Former Williams Air Force Base

**BRAC Cleanup Team Call
23 November 2015**

**Former Liquid Fuels
Storage Area
Remedial Action**

Site ST012 SEE System SEE to EBR Transition Criteria

Average Temperatures by Zone

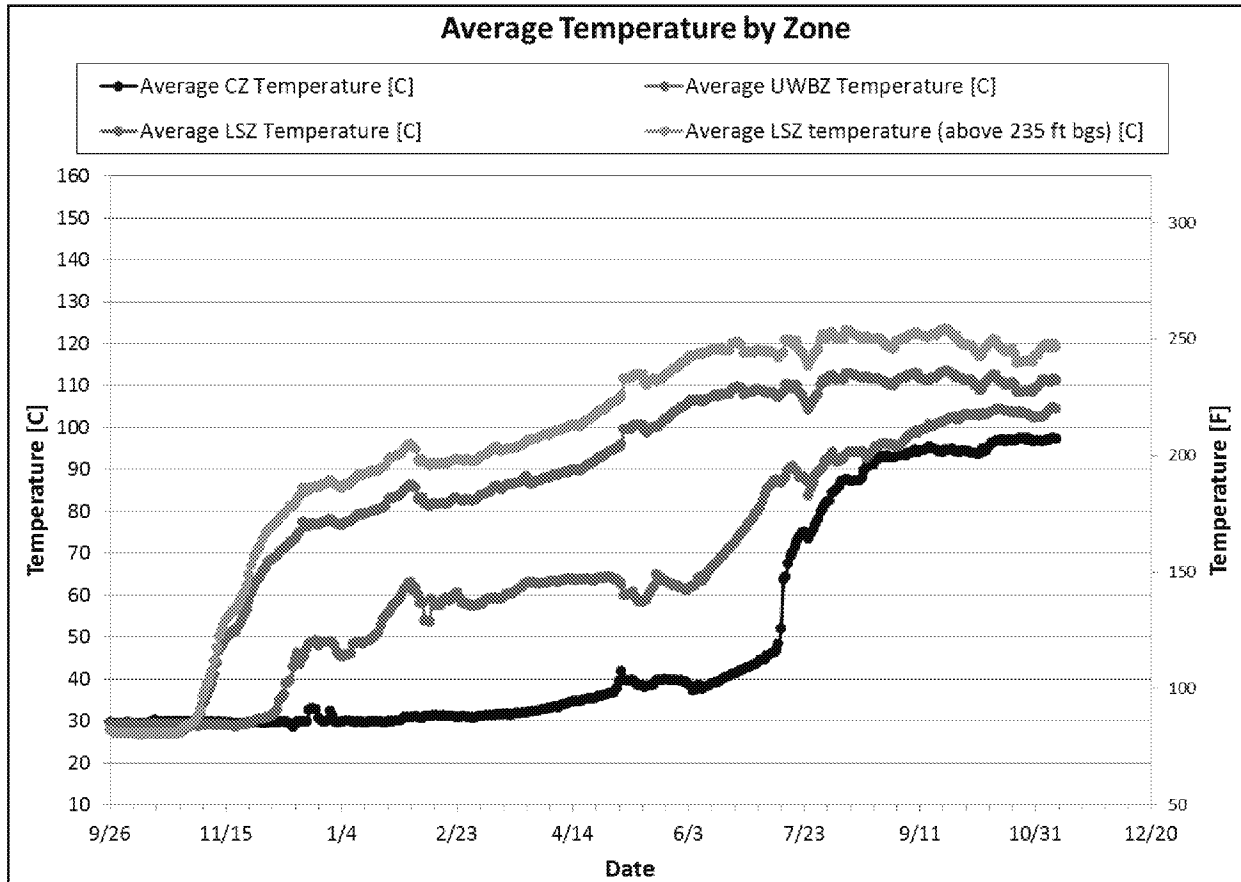
- ***Analysis: According to slide 20 from Oct 15, the target temperature for the CZ is ~ 100C, which has almost been met. The target for the UWBZ is ~114C, which has almost been met. The target for the LSZ is ~134C, which has not been met.***

- Average temperatures continue to increase in CZ and UWBZ
- LSZ temperature sensors 240 ft bgs and lower generally do not show steam temperatures

- Target treatment temperatures achieved in all zones (LSZ <235 ft bgs)

Site ST012 SEE System Daily Mass Removal

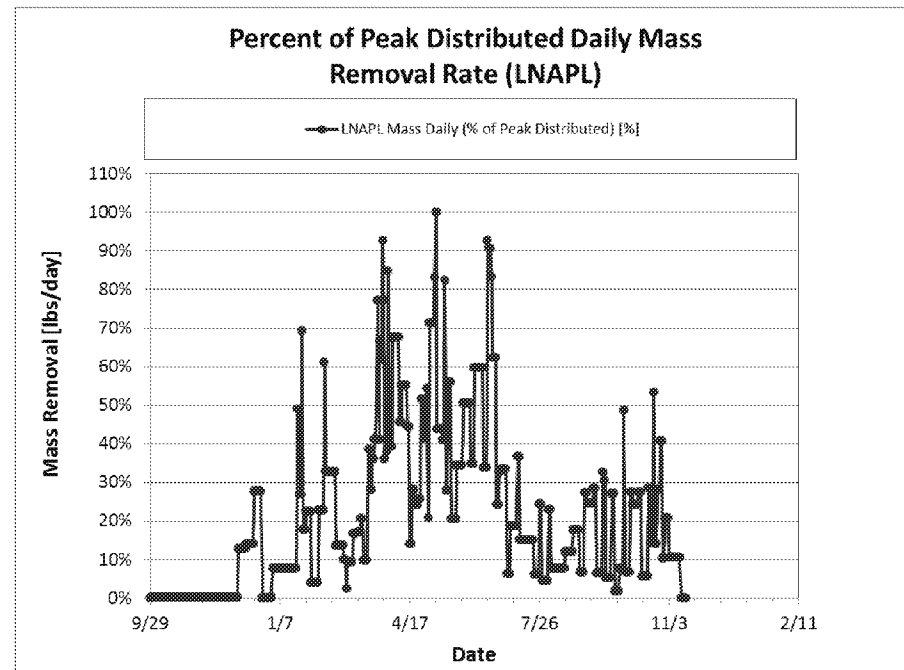
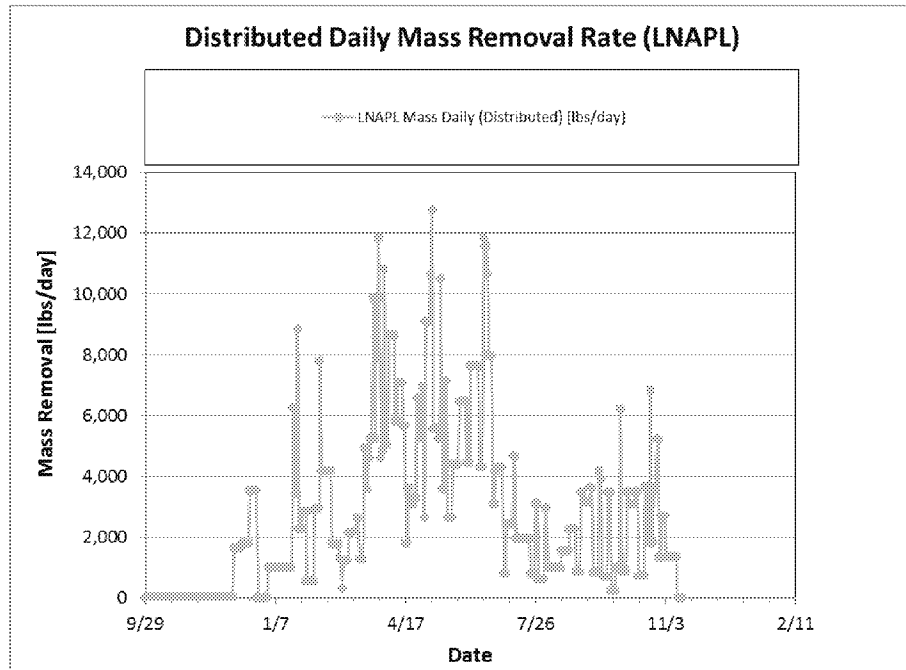
- Analysis: Current LNAPL recovery is at 30% of peak removal rate; vapor recovery is 50% of peak removal rate; Criteria for termination of steam injection has not been met. EPA considers the criteria of 10% of the peak mass recovery to be high compared to the mass recovery rates that have been used to support thermal treatment termination at other sites. We cannot support termination of treatment when thousands of pounds of contaminant mass are being extracted daily.**

- Mass removal target of ~10% of peak is appropriate for ST012 because of the follow-on EBR and natural attenuation planned
- Mass removal peaked on 14 May 2015 at 22,506 lbs/day
- Mass recovery has dropped to <10% of the peak
